**SUBJECT:** NuScale Power, LLC Response to NRC Request for Additional Information No. 270 (eRAI No. 9185) on the NuScale Design Certification Application

NuScale Response to NRC Request for Additional Information eRAI No. 9185

**NRC Question No.:** 02.03.04-1

Figure 2.3-2: Source to Control Building Door Distances

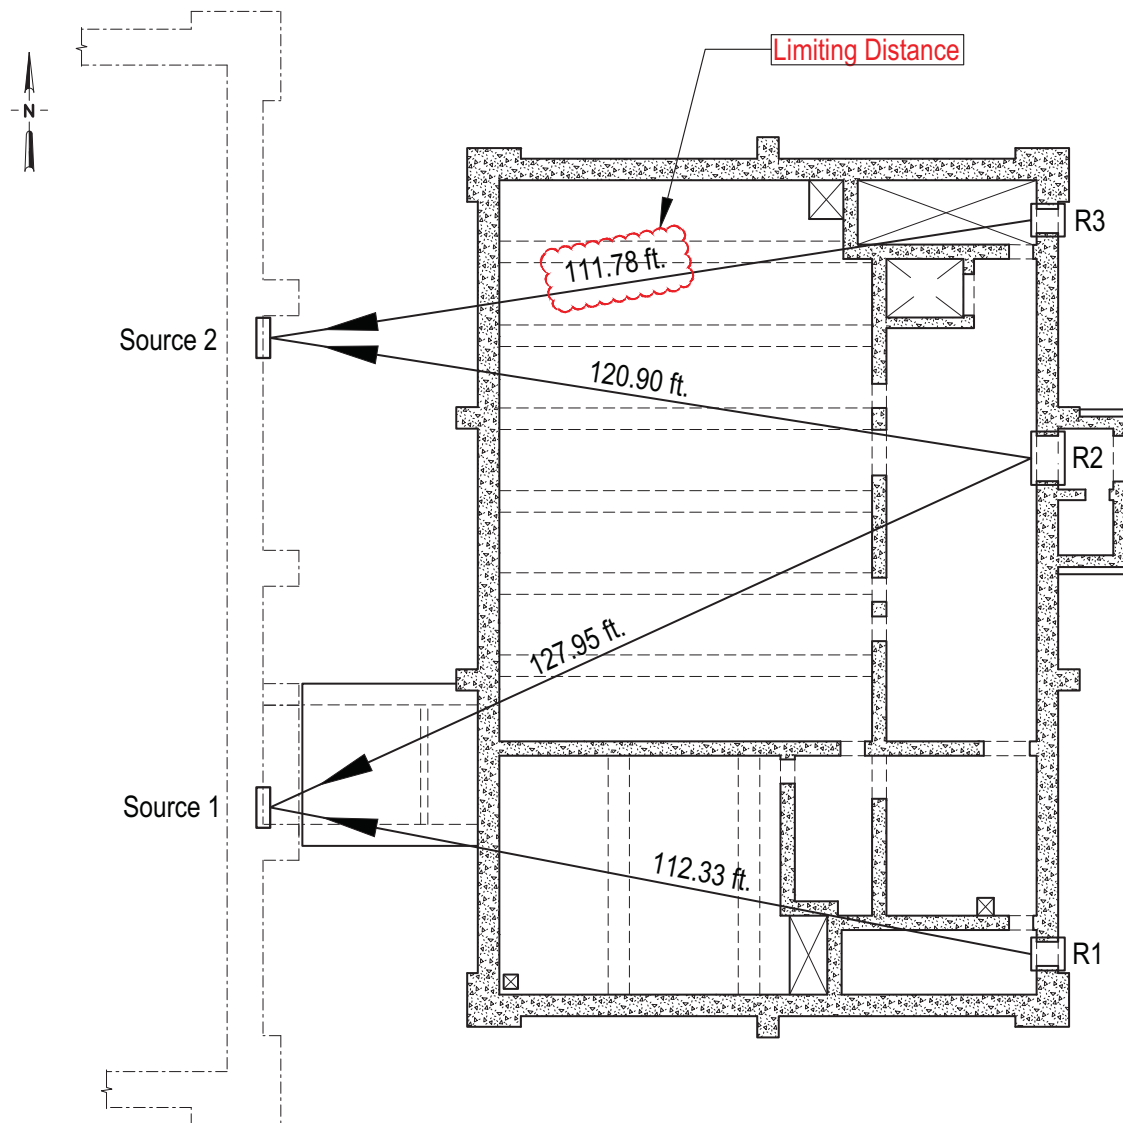
- a. Please revise the DCA FSAR to include all the NuScale nuclear plant configuration data required by COL applicants to perform atmospheric dispersion modeling (e.g., release heights, intake heights, building area).
  - b. Please revise the directions shown in NuScale DCA FSAR Tier 2, Figures 2.3-2 and 2.3-3 from "source to receptor" directions to "receptor to source" directions.
  - c. Please provide the basis that supports NuScale's position that the two source locations shown in NuScale DCA FSAR Tier 2, Figures 2.3-2 and 2.3-3 (e.g., the reactor building SE and NE single personnel doors) are the limiting source locations for all radiological accidents evaluated in the NuScale DCA FSAR.
-

b. FSAR Tier 2, Figures 2.3-2 and 2.3-3 are revised as requested, as shown in the attached markup. Note that the degrees are no longer shown. This is because the degree input to NARCON is based on the angle between the source and the receptor in relation to the true north which the weather data is based on. Since the layout of the buildings in the FSAR are in relation to an arbitrary "site north" which may or may not align with the as constructed plant's orientation to true north, this NARCON input can not be generically stated and the COL applicant will have to establish the correct input to NARCON if they have to redo the control room dose analysis.

c. The two source locations shown in Figures 2.3-2 and 2.3-3 are the limiting source locations because they are the closest source locations to the main control room personnel doors and main control room HVAC intake. FSAR Tier 2, Section 2.3.4 has been updated as shown in the attached markup to clarify this.
